QUESTION 005.1

The statement in Section 5.2.1.1 of the FSAR with regard to your compliance with 10 CFR Part 50, Section 50.55a, Codes and Standards Rule, is incorrect as a number of Quality Group A components within the reactor coolant pressure boundary are not in conformance with the applicable ASME Boiler and Pressure Vessel code and addenda as required by the rule.

FIGURE 021.72-1, Rev 47

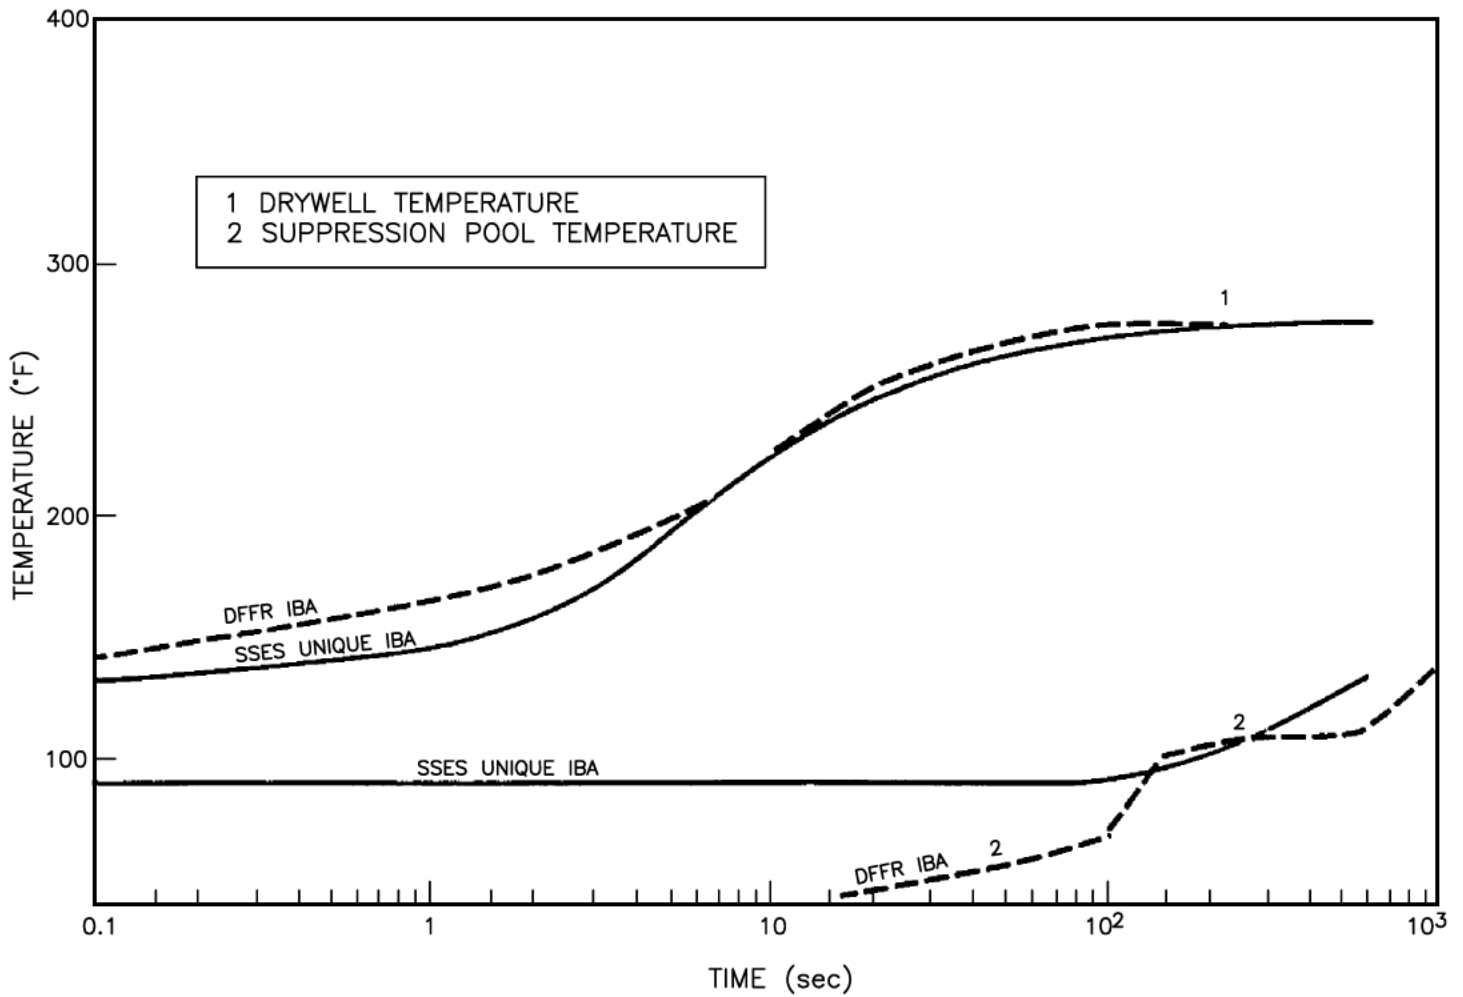
Statements are made in Subsections 4.2.3.2 and 4.2.3.3 of the DAR that plant unique data of the Susquehanna SES intermediate break accident (IBA) and small break accident (SBA) are estimated from curves for a typical Mark II containment. Discuss the applicability of these analyses (e.g., power level, initial conditions, downcomer configuration, etc.) to Susquehanna SES.

The Susquehanna SES FSAR Subsections 6.2.1.1.3.3.4 and 6.2.1.1.3.3.5 give consideration to the SBA and IBA conditions and FSAR figures 6.2-14 and 6.2-15 give the IBA unique curves for Susquehanna SES based on the initial conditions as given in FSAR Tables 6.2-1 thru 6.2-4. In comparing the IBA Susquehanna SES unique FSAR figures with the Susquehanna SES DAR figures 4-50, 4-51 and 4-52, which are generic DFFR, SBA and IBA, it can be seen that basically the generated curves provide similar design basis mass energy data. (See figures 021.72-1 and 021.72-2) Thus we expect the Susquehanna SES SBA conditions to be similar also to the DFFR (or DAR) figures. The parameters for the DFFR and Susquehanna SES are provided in DFFR (NEDO 21061) Table 4-1 and Susquehanna SES FSAR Tables 6.2-1 and 6.2-4 respectively. The differences in parameters are as follows:

FIGURE 032.6-1, Rev 47

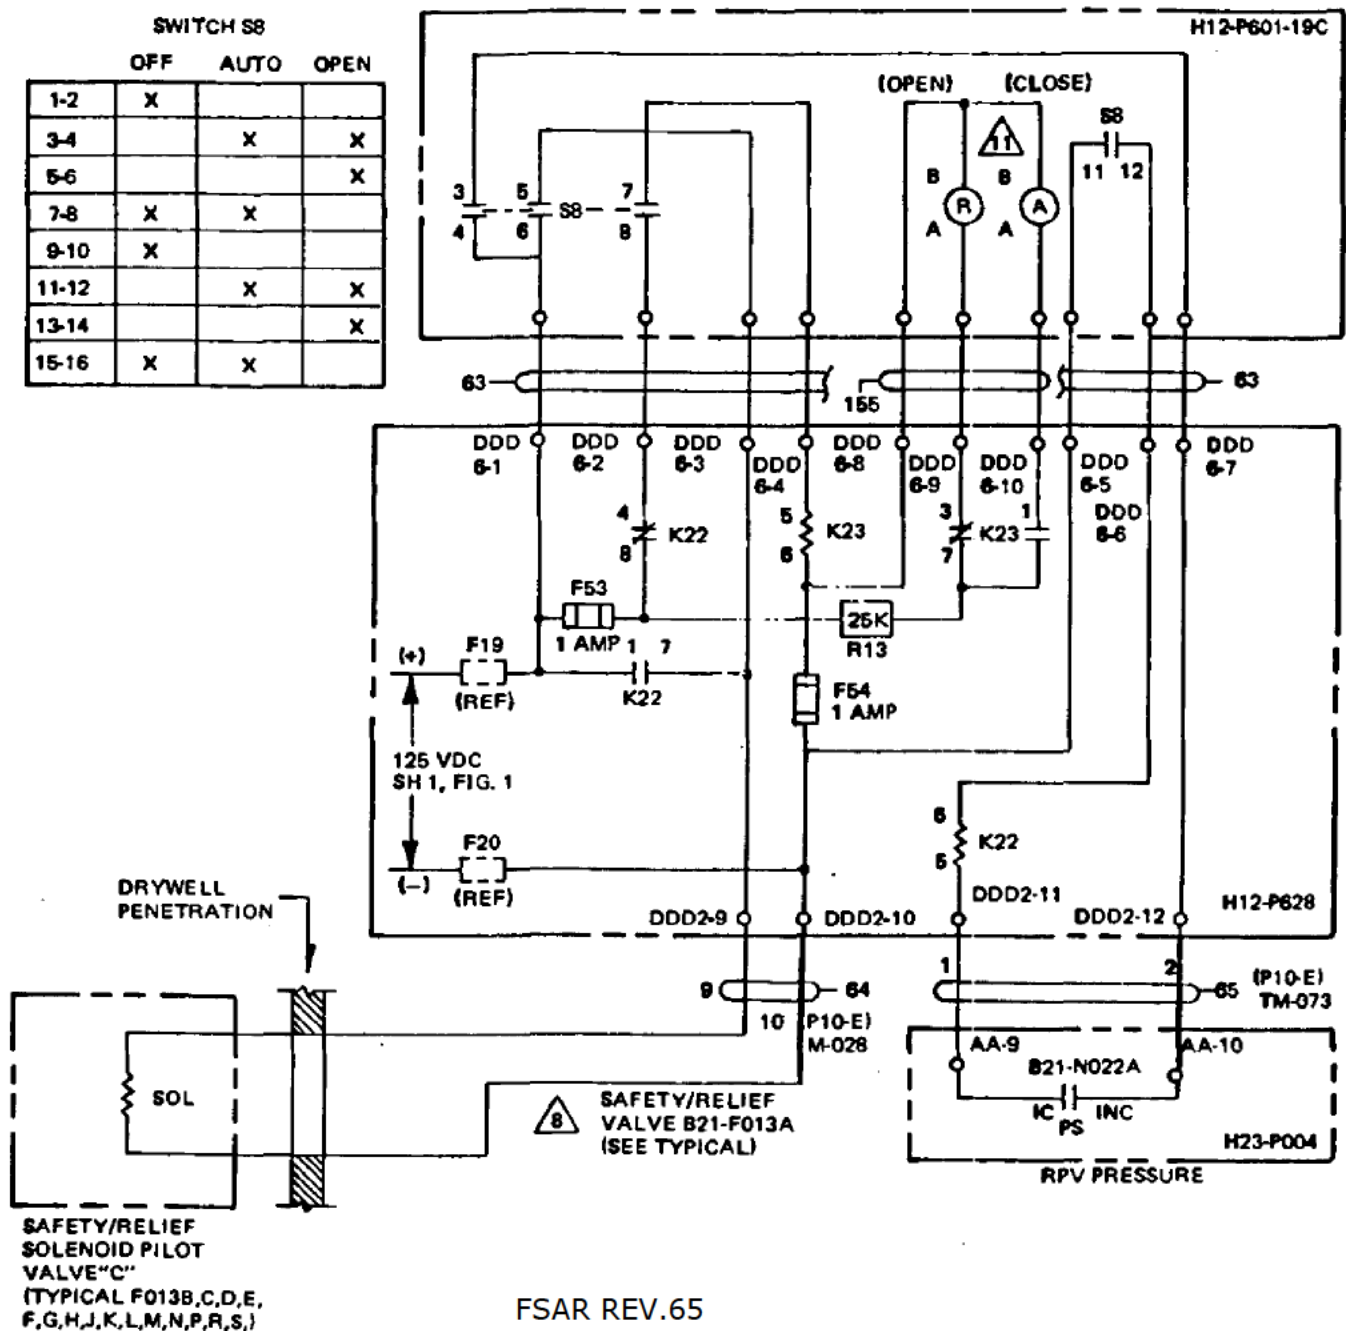
Provide a complete discussion of the instrumentation (pressure switches, manual control switches, and wiring) associated with the nuclear pressure relief system described in Section 5.2.2.4 of the FSAR which actuate the safety/relief valves on an overpressure event or through operator action. Include elementary wiring diagrams as appropriate.

The pressure relief instrumentation which controls the electrical operation of each valve is shown on Figure 032.6-1 (typical diagram). Each valve has its own pressure switch which acts to open the valve directly when it senses high vessel pressure unless the control switch (S8 in the diagram) is in the "OFF" position.

This control switch is a maintained contact switch which may be selected for one of three positions: OFF, AUTO or OPEN. With the switch in "AUTO", pressure at or above the setpoint closes the pressure switch which actuates a relay which opens its respective valve while simultaneously switching indicating lights. When pressure drops to an acceptable level, the pressure switch reopens causing the relay to deenergize and reclose the valve.

FIGURE 032.57-1, Rev 47

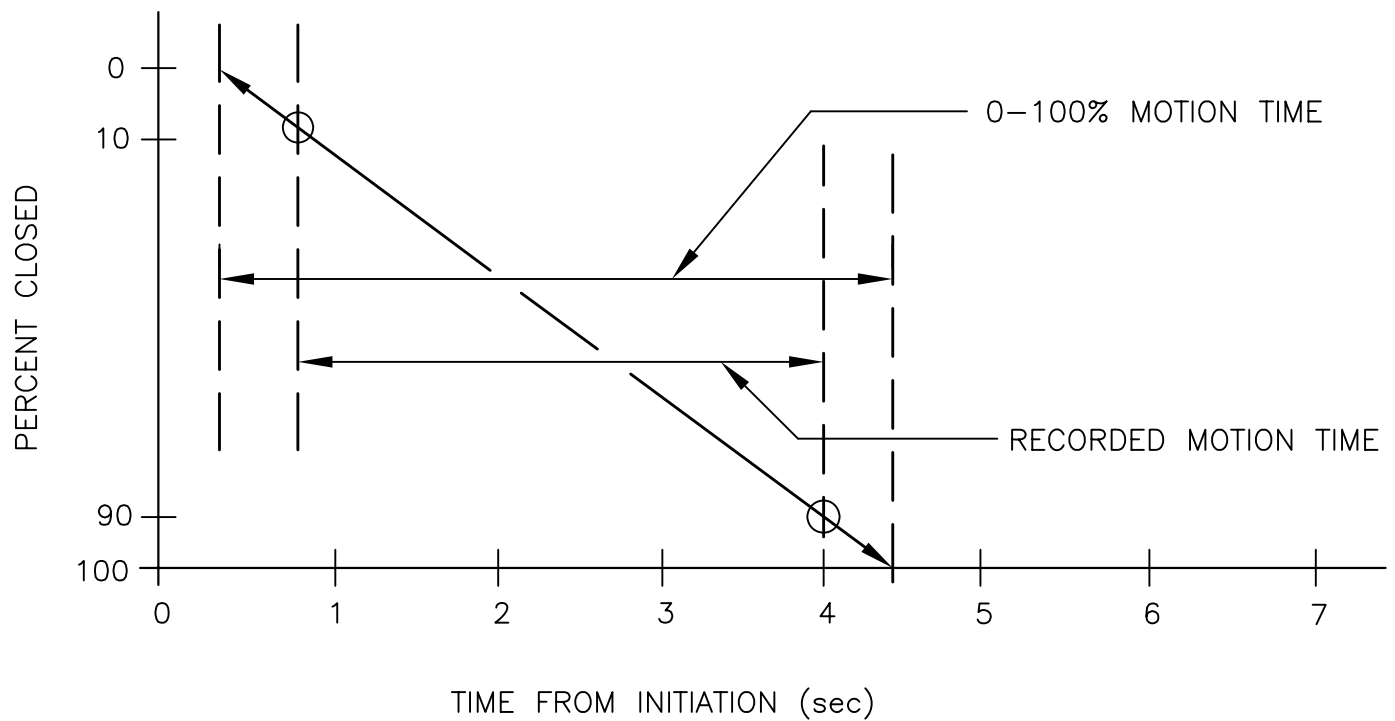
Describe test method to be used to verify closing times for main steamline isolation valves are within limits of technical specifications. Identify any special design features to facilitate this test. Table 6.2-12 is referenced for closure times of main steamline isolation valves, but time has been omitted from that table. What is the range of acceptable closure times?

The determination of the MSIV closure was an extrapolation from the position lights as illustrated by Figure 032.27. The closure time is the summation of the time between the initiation signal and the 90% closed light plus  $1/9$  times the time interval between the initiation and the 90% closed lights.
